Access Compliance Report

Public Rights-of-Way

(Curb Ramps)

Intersection ID: 10276	Main Street: ASHLEY_RD	Cross Street: TUCKASEEGEE_RD	Location: SW
ADA ID: ABCD1A30BAC8	Ramp Type: Perp	Initial Pass/Fail: Fail	Overall Compliance: No
		Severity Score: 8.75	
Codes/Mitigation Info/Possible Solution		Field Measurements/Component Compliance

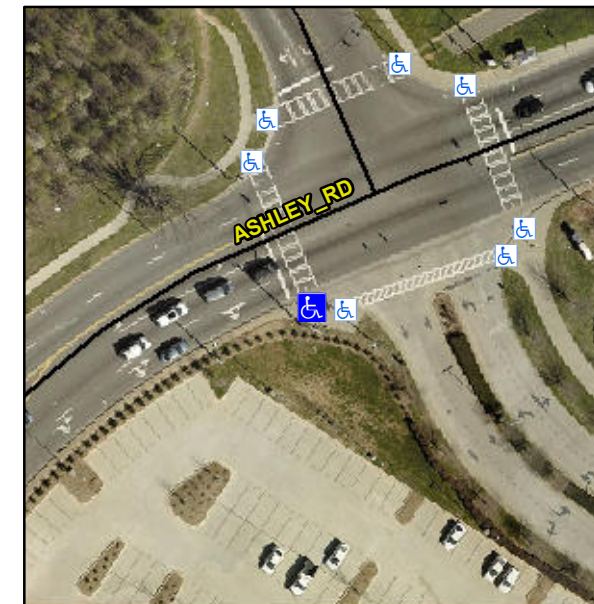
Not Found, R304.5.1

Compliance	Description	Data	Compliance	Description	Data
N/A	Ramp Length (in)	84.4	Yes	Ramp Slope (%)	7.6
No	Ramp Width (in)	47.0	Yes	Ramp XSlope (%)	0.8
N/A	Flare Type LT	N/A	N/A	Flare Type RT	N/A
N/A	Flare Slope LT (%)	N/A	N/A	Flare Slope RT (%)	N/A
N/A	Flare Traversable LT?	N/A	N/A	Flare Traversable RT?	N/A
N/A	Landing Length (in)	N/A	N/A	DWS Provided?	N/A
N/A	Landing Width (in)	N/A	N/A	DWS Contrast?	N/A
N/A	Landing Slope (%)	N/A	N/A	DWS Length (in)	N/A
N/A	Landing X Slope (%)	N/A	N/A	DWS Full Width?	N/A
N/A	Landing Curb? (Y/N)	N/A	N/A	DWS Offset (in)	N/A
N/A	Shared Landing?	N/A			
N/A	Gutter Ponding?	N/A	N/A	Gutter Slope (%)	N/A
N/A	Gutter Lip Ht (in)	N/A	N/A	Gutter X Slope (%)	N/A
N/A	Painted X Walk1?	Yes	N/A	Painted X Walk2?	N/A
	X Walk 1 Direction	To N		X Walk 2 Direction	N/A
N/A	X Walk 1 Width (in)	113.0	N/A	X Walk 2 Width (in)	N/A
	X Walk 1 Slope (%)	2.2		X Walk 2 Slope (%)	N/A
	X Walk 1 X Slope (%)	0.9		X Walk 2 X Slope (%)	N/A

Remove & Replace Entire Ramp.
